JAMES A. FITZPATRICK NUCLEAR POWER PLANT

AMENDMENT TO FACILITY OPERATING LICENSE

Amendment No. 3
License No. DPR-59

SAFETY EVALUATION BY THE OFFICE OF NUCLEAR REACTOR REGULATION

FIG. 6.1-2
JAF-NMP SITE ORGANIZATION

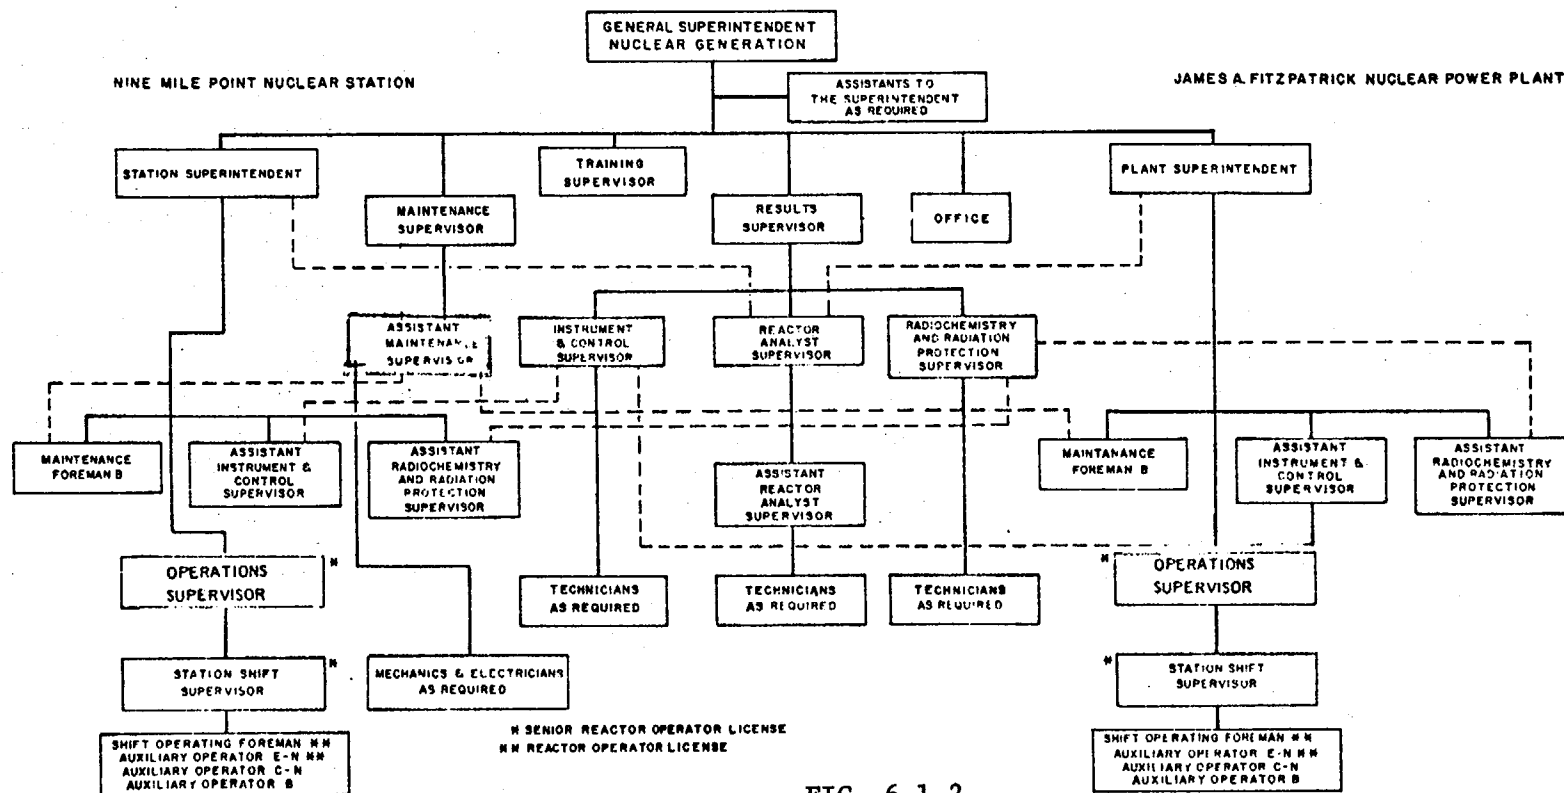
Figure 6.1-2, p. 283. The licensee desires to change the titles of the Assistant to the Plant Superintendent for Operation (Nine Mile Point Nuclear Station) to Operations Supervisor and the Assistant to the Plant Superintendent for Operation (FitzPatrick Nuclear Power Plant) to Operations Supervisor. These title changes are acceptable as they reflect the titles used in the present organization.

TS 6.3A2, p. 248. This change is related to the change above and makes the TS section that references Fig. 6.1-2 give the same position titles as Fig. 6.1-2. Only the position titles are revised, not the duties of the incumbents, thus the changes are acceptable.

FIG. 6.5-1

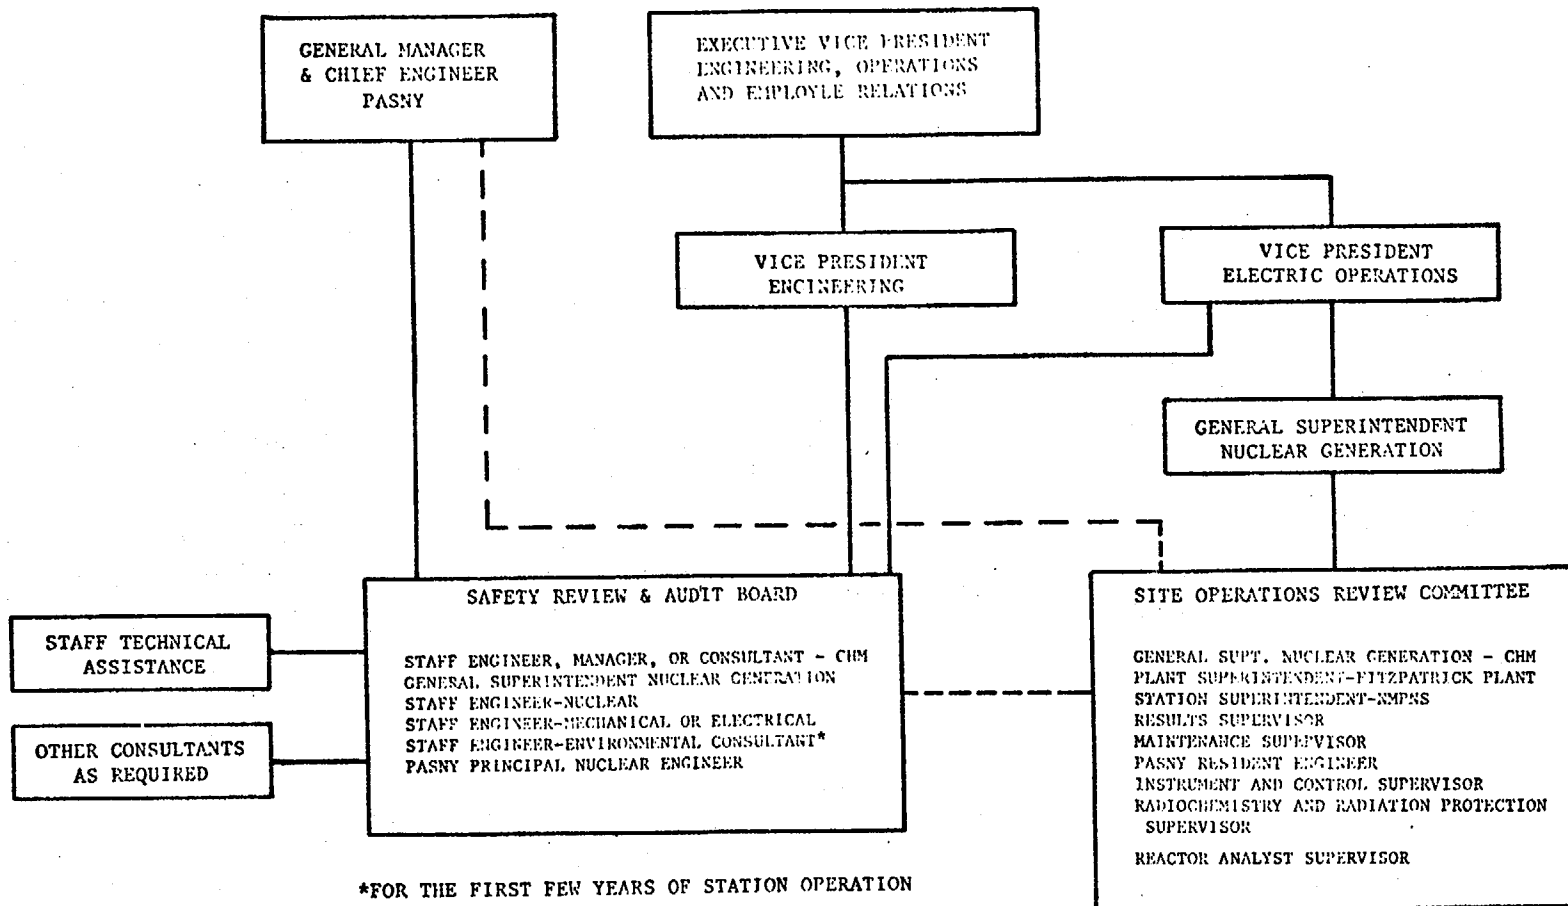
Figure 6.5-1, p. 284. The licensee desires to have the Site Operations and Review Committee (SORC) report to the General Superintendent Nuclear Generation; previously the SORC had only an advisory organizational tie between the Safety Review and Audit Board and the PASNY General Manager and Chief Engineer. The advisory ties are retained. This change is acceptable as it reflects the current organizational role of the SORC and reflects the current NRC position as given in the Standard Technical Specifications.
